# Access Compliance Report

## Public Rights-of-Way

### (Curb Ramps)

Intersection ID: 52476	Main Street: WHITEHALL EXECUTIVE CENTER DR	Cross Street: N/A	Location: SW
ADA ID: B10848B805D9	Ramp Type: Perp	Initial Pass/Fail: Pass	Overall Compliance: No
Codes/Mitigation Info/Possible Solution		Field Measurements/Component Compliance	
Severity Score: 2.5

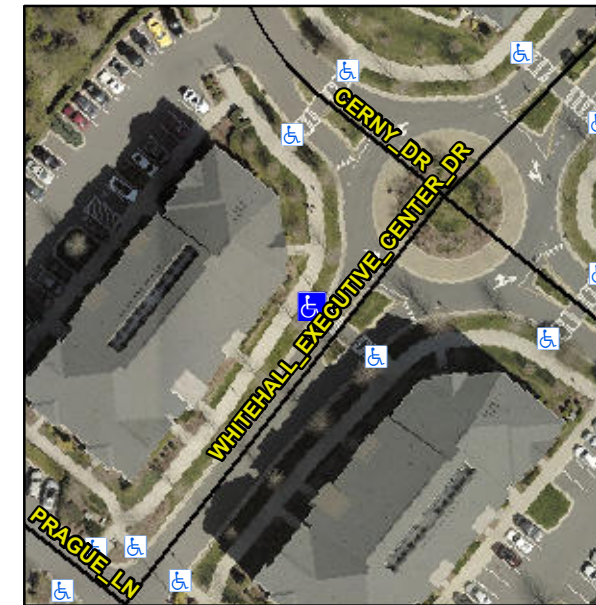
**R304.2.2-Perp, R304.3.2-Para,  
R305.1.4**

Compliance	Description	Data	Compliance	Description	Data
N/A	Ramp Length (in)	95.0	Yes	Ramp Slope (%)	7.3
Yes	Ramp Width (in)	100.0	Yes	Ramp XSlope (%)	0.2
Yes	Flare Type LT	Curbed_NoWalkSurface	Yes	Flare Type RT	N/A
Yes	Flare Slope LT (%)	N/A	N/A	Flare Slope RT (%)	N/A
N/A	Flare Traversable LT?	No	N/A	Flare Traversable RT?	No
Yes	Landing Length (in)	96.0	Yes	DWS Provided?	Yes
Yes	Landing Width (in)	115.0	Yes	DWS Contrast?	Yes
No	Landing Slope (%)	3.0	Yes	DWS Length (in)	24.0
Yes	Landing X Slope (%)	0.4	No	DWS Full Width?	No
N/A	Landing Curb? (Y/N)	No	Yes	DWS Offset (in)	0.0
N/A	Shared Landing?	No			
Yes	Gutter Ponding?	No	Yes	Gutter Slope (%)	4.8
Yes	Gutter Lip Ht (in)	0.0	Yes	Gutter X Slope (%)	0.8
N/A	Painted X Walk1?	Yes	N/A	Painted X Walk2?	N/A
	X Walk 1 Direction	To SE		X Walk 2 Direction	N/A
N/A	X Walk 1 Width (in)	105.0	N/A	X Walk 2 Width (in)	N/A
	X Walk 1 Slope (%)	2.5		X Walk 2 Slope (%)	N/A
	X Walk 1 X Slope (%)	2.1		X Walk 2 X Slope (%)	N/A

Yes	Ramp inside XWalk1?	Yes	N/A	Ramp inside XWalk2?	N/A
	Road Slope (%)	N/A	N/A	Clear Space?	Yes
	Road X Slope (%)	N/A	N/A	Clear Space to XWalk (in)	N/A
Yes	Any Obstructions?	No	Yes	Storm Grate/Utility Hazard?	No
	Obstruction Type			Storm Grate/Utility Type	
		N/A			N/A
			Yes	Surface Condition? (G/P)	Good

**Remove & Replace Entire Ramp.**
